Z-51

APPLICANT: Arrowhead Real Estate Partners, LLC

PETITION NO.: Z-51

PETITION FOR: RA-5

Received by
Zoning on
2-15-13
J.P.P.

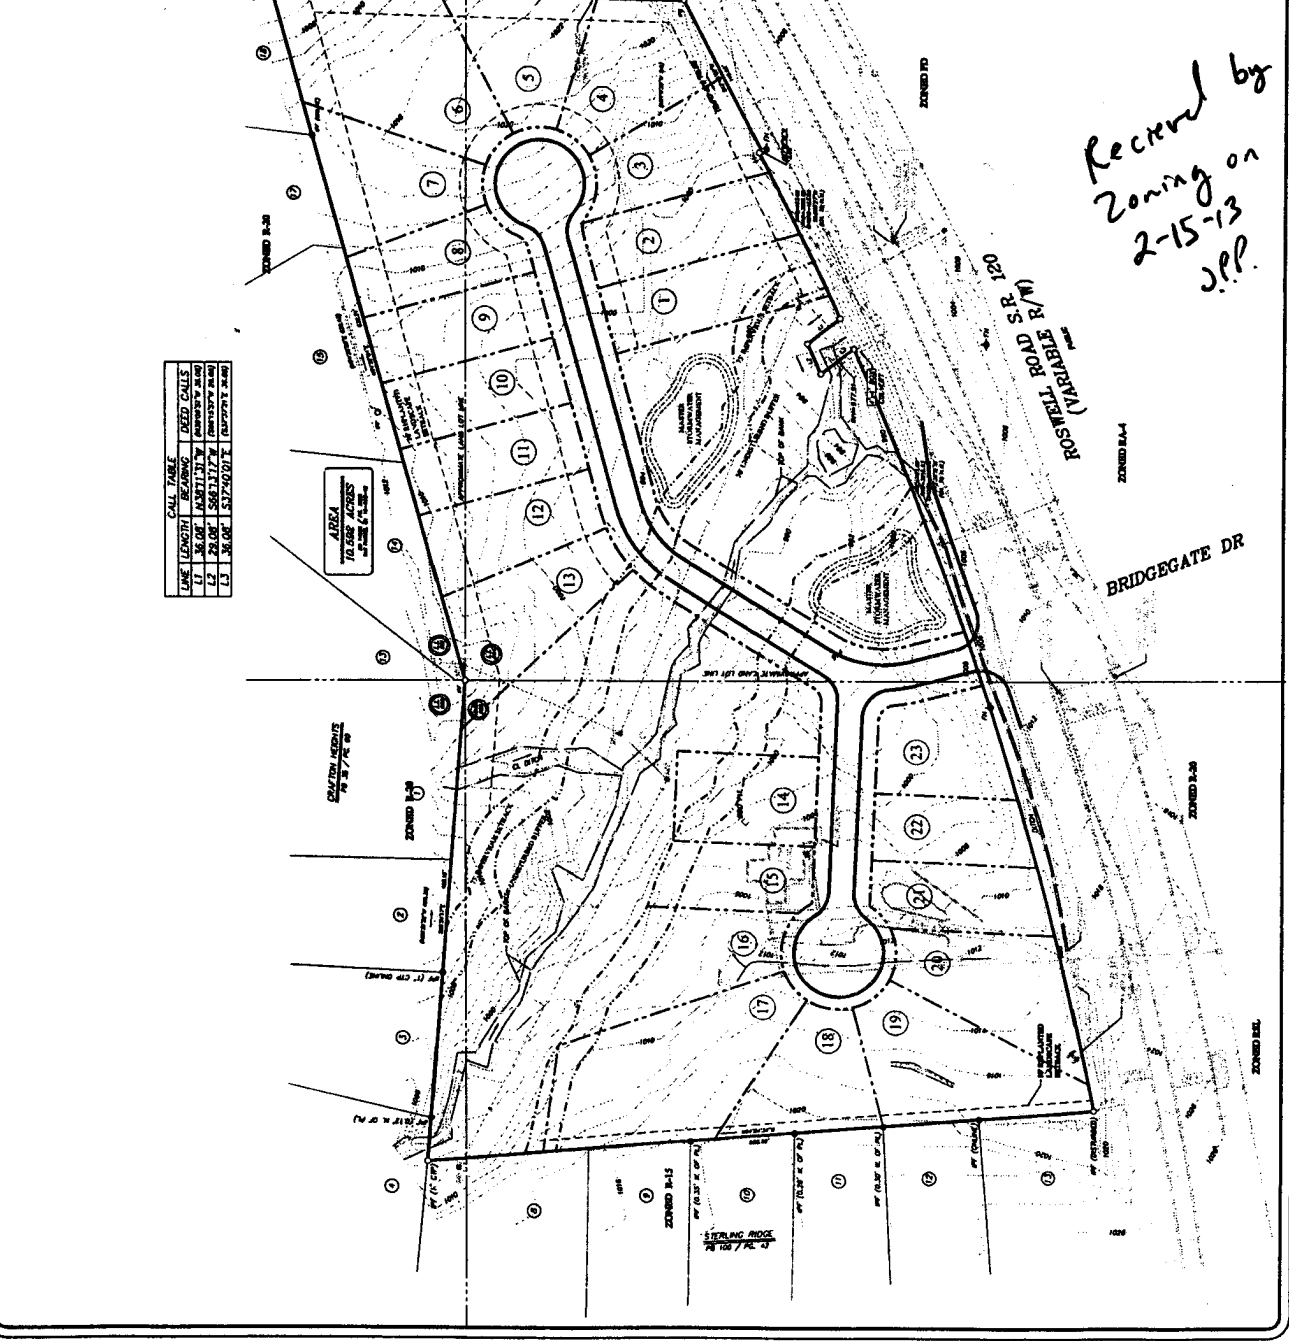
ADDITIONAL COMMENTS (Based on Revised Plan submitted 2/15/2013)

1. This site is located just north of Roswell Road and is bounded by Sterling Ridge S/D to the west, Crafton Heights and Stone Hill S/Ds to the north and Stone Hill S/D to the east. The site is dominated by a stream the runs diagonally across the site that roughly divides the parcel in half. Average slopes on the site are approximately 10%.
2. One of the proposed detention ponds will be located near the entrance adjacent to Roswell Road. Adequate landscaping should be provided to visually screen the pond from the Roswell Road R/W..
3. The embankment created by Roswell Road creates a significant flooding potential for this parcel. County Code will require that all minimum finished floor elevations be at least 2 feet above the overflow low point of Roswell Road.
